AA - NEWTON LONGVILLE TRAFFIC CALMING SCHEME

ROAD SAFETY ASSESSMENT REPORT.

South West Milton Keynes Development, Proposed Traffic calming scheme, Newton Longville Village.

Designer's Response to 'Road Safety Assessment'

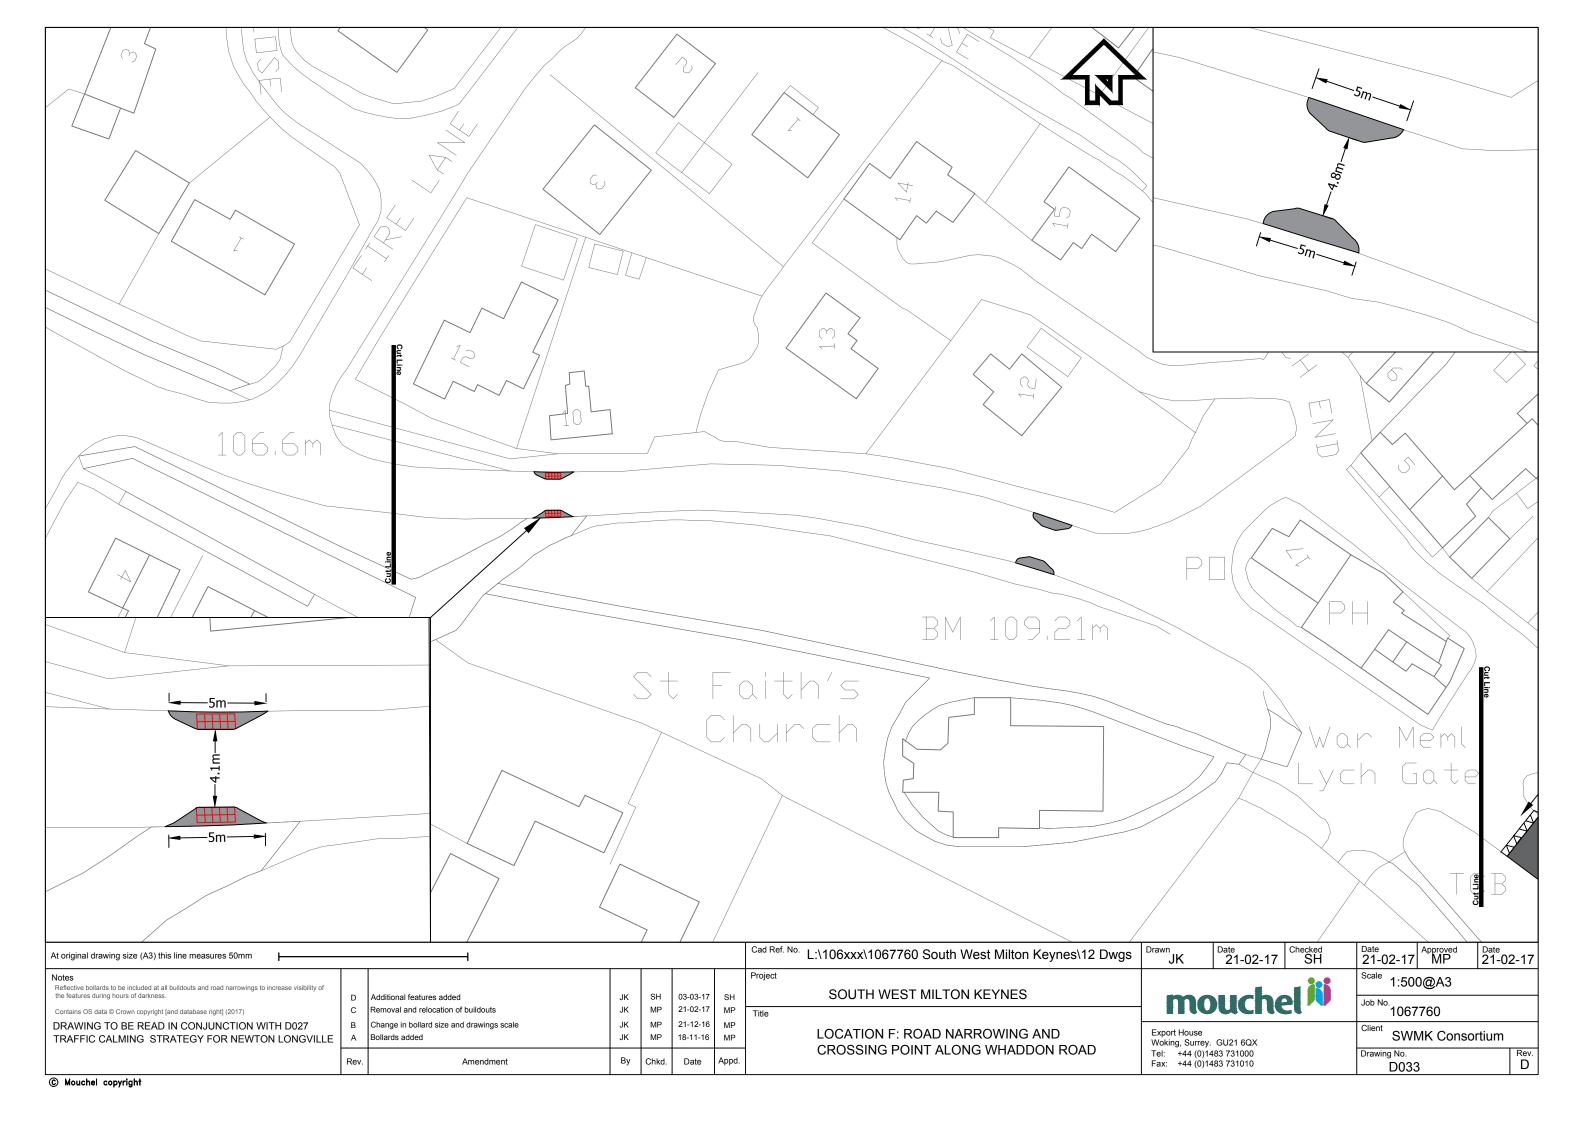
3.1 PROBLEM

<u>Location A - existing speed limit boundary to Whaddon Road.</u>
Compliance with the change of speed limit.

The proposal to install a 40 mph speed limit roundel is unnecessary, as it currently exists. However the road

environment doesn't encourage drivers to lower their speed from the national speed limit to the north. Drivers may continue at a higher speed over the bridge with a risk of sudden braking at high speed and loss of control or head on collisions.

Install red surfacing under the 40 mph roundel, possibly as a lateral gateway across the width of the carriageway. Red surface under the 'slow' marking.

"Location: A - Existing speed limit boundary to Whaddon Road. Compliance with the change of speed limit.

Summary: The proposal to install a 40 mph speed limit roundel is unnecessary, as it currently exists. However the road environment doesn't encourage drivers to lower their speed from the national speed limit to the north. Drivers may continue at a higher speed over the bridge with a risk of sudden braking at high speed and loss of control or head on collisions

Recommendation: Install red surfacing under the 40 mph roundel, possibly as a lateral gateway across the width of the carriageway. Red surface under the 'slow' marking."

2.1 There is no proposal to introduce a 40mph roundel at the speed limit boundary – Drawing D028B shows the existing speed limit boundary, not a proposal. However, red surfacing can be installed under the existing 40mph roundel. This can be included in the detailed design stage of the NLTC scheme by BCC. Drawing D028D shows this change.
